GOVERNMENT OF THE DISTRICT OF COLUMBIA
DEPARTMENT OF GENERAL SERVICES

DCAM-14-CS-0117
Department of Corrections Housing Unit Renovations

Addendum No. 2
Issued: March 13, 2014

Exhibit 1

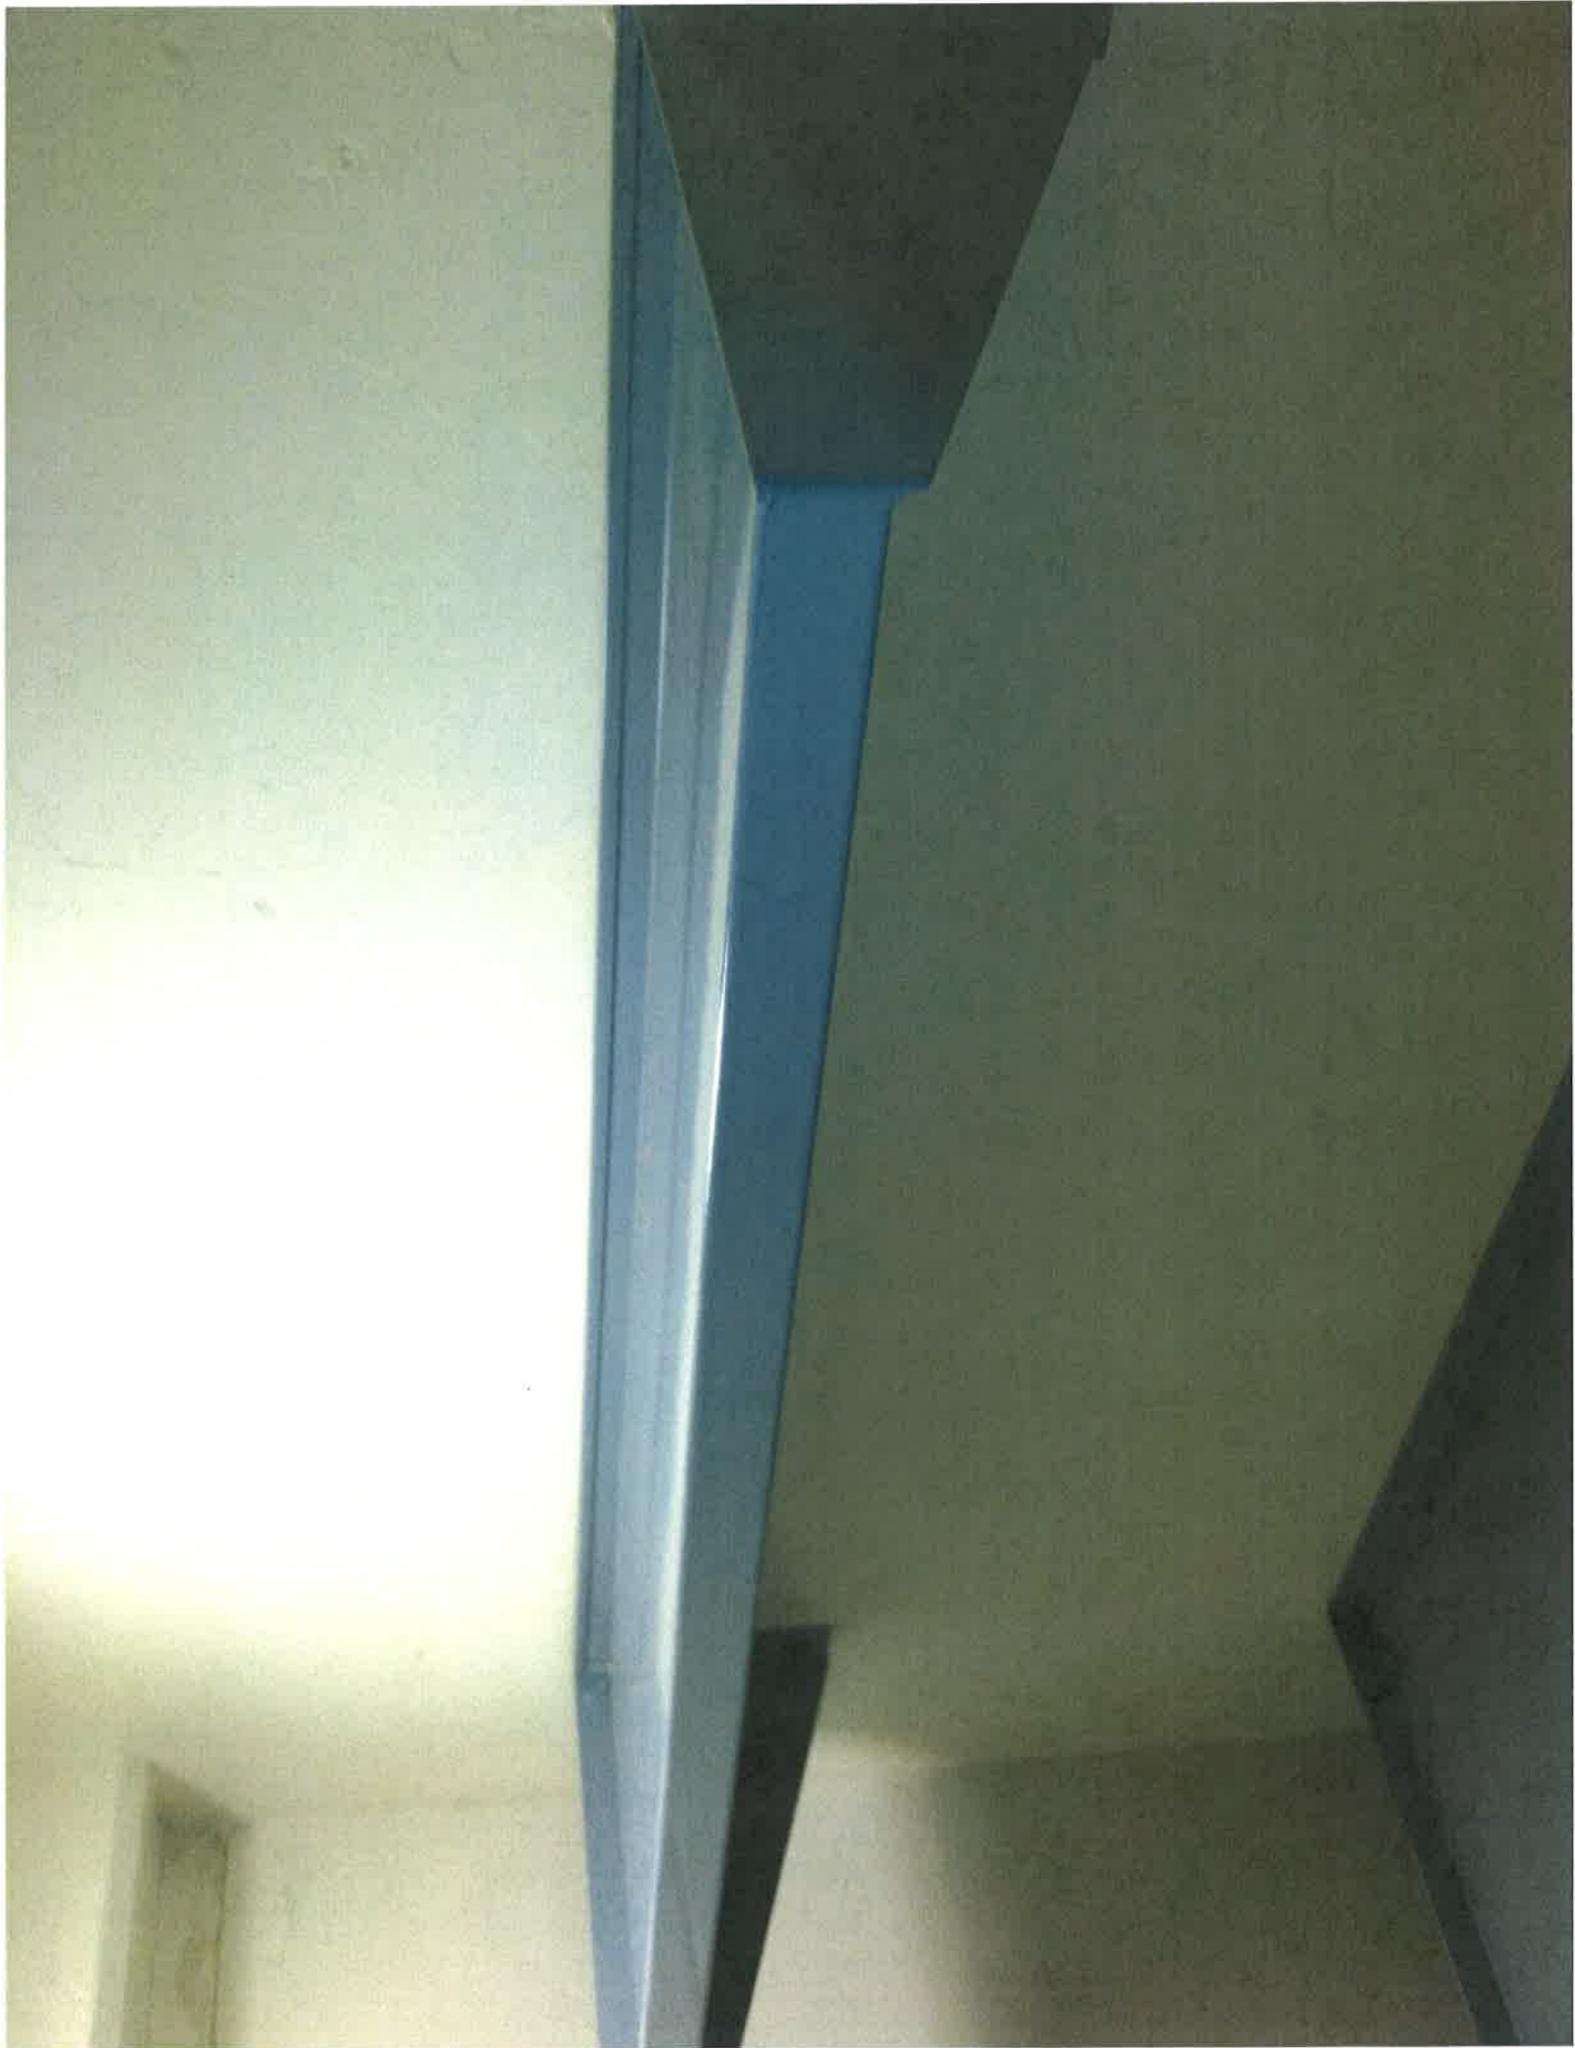
- 1. Please provide specifications and any other additional information regarding the bunks, cell doors and vent covers.**

7. Please confirm that security caulking is required at the entire perimeter of the bunks. – Please advise if pick resistant (flexible) or pick proof (rigid) security caulk is required if needed at the bunks.

8. Please provide the size of the bolts required for attaching the bunks, ie 1/2", 5/8", 3/4" etc. Also advise if they will be plain steel, galvanized steel or stainless steel.

The following specifications and images are attached to this Addendum:

Exhibit 1: Sample bunk bed (new).

Pick proof (rigid) security caulk is required.

Bolts need to be galvanized steel and size 5/8".

Exhibit 2

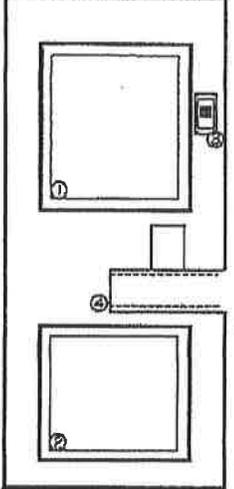
12. The door hanger and bottom guides are not manufactured by the hollow metal door manufacturers. The door hanger and guides, although welded to the doors are in fact part of the Southern Folger locking device, not the Trussbilt door. They are plug welded to the hollow metal doors. It is possible to remove the existing hangers and guides from the existing doors to be re-used but the existing doors will be damaged in the process. Please confirm that damage to the existing doors, if they are being salvaged, is acceptable. The alternative is purchasing new hangers and guides from Southern Folger and a 60 day contract period will not allow for that procurement process.

Exhibit 2: Door specifications (Trussbilt or equal) and Pictures of sample new door.

Damage to existing doors is acceptable. The priority is to not damage the door hanger and bottom guides.

Exhibit 3

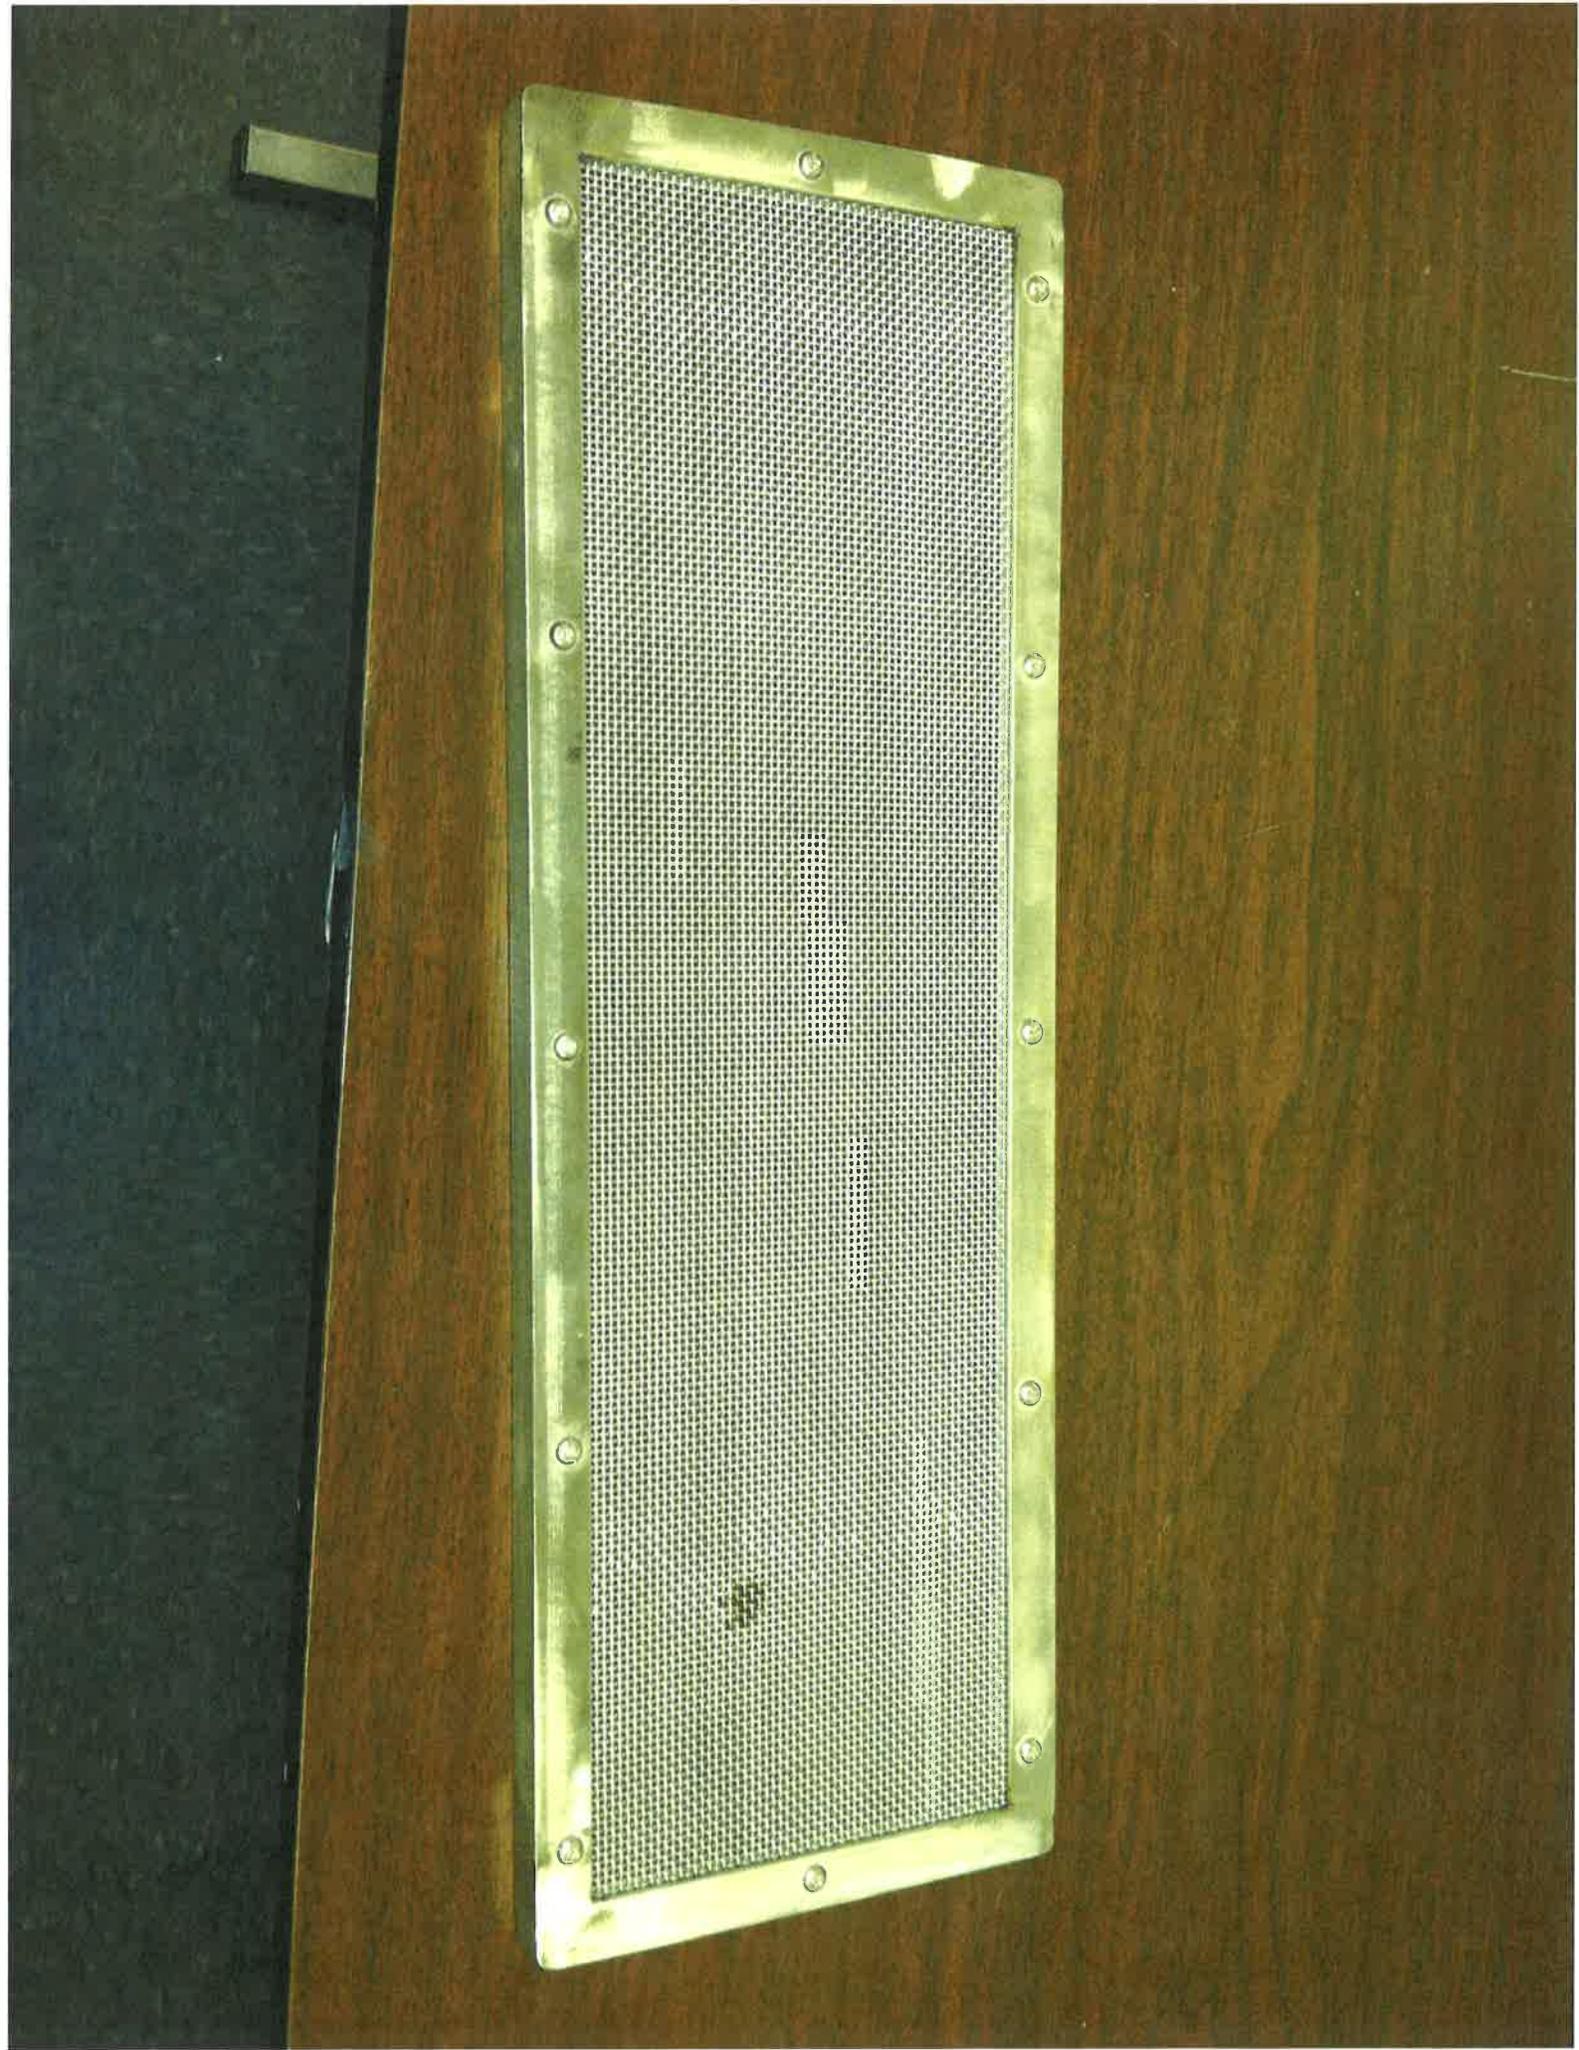
10. B.2.2.c mentions stainless steel but then mentions finish painting. Please confirm that the stainless steel screen assemblies will not need to be painted and that they should have a #4 stainless steel finish.

Exhibit 3: Sample vent cover screen (new), sample vent grill (existing).

Stainless steel vent screens shall be installed with stainless steel security screws and will not require painting.
